Delegated Report

Application No: 20220464
Location: 130 Old Road East, Gravesend DA12 1PF
Description: Retention of outbuilding to be a games room/gymnasium
Applicant: Mr Rijvant Thamey
Site Visit Date: Various

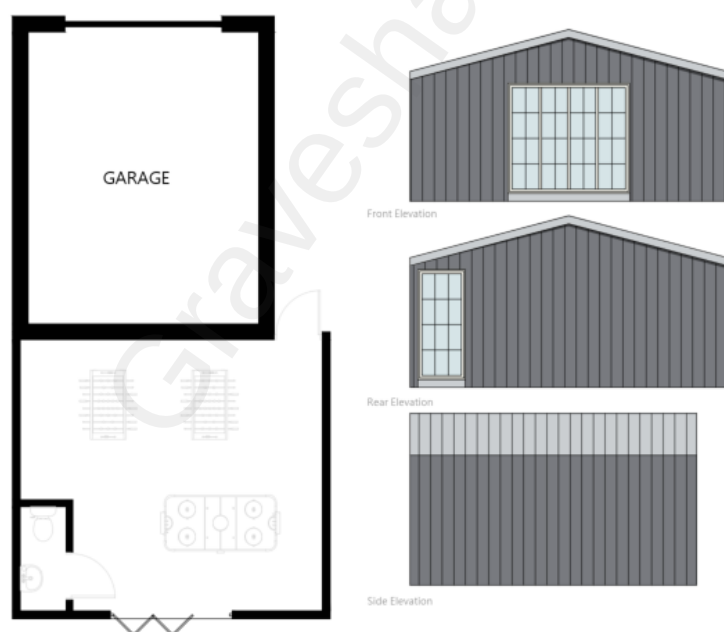
The main difference is the depth has been decreased from approx. 5.3m to 3.8m and the double width patio doors have been replaced with a single door. The decrease in depth has been replaced by a veranda/overhang so the roof depth and footprint remains the same.
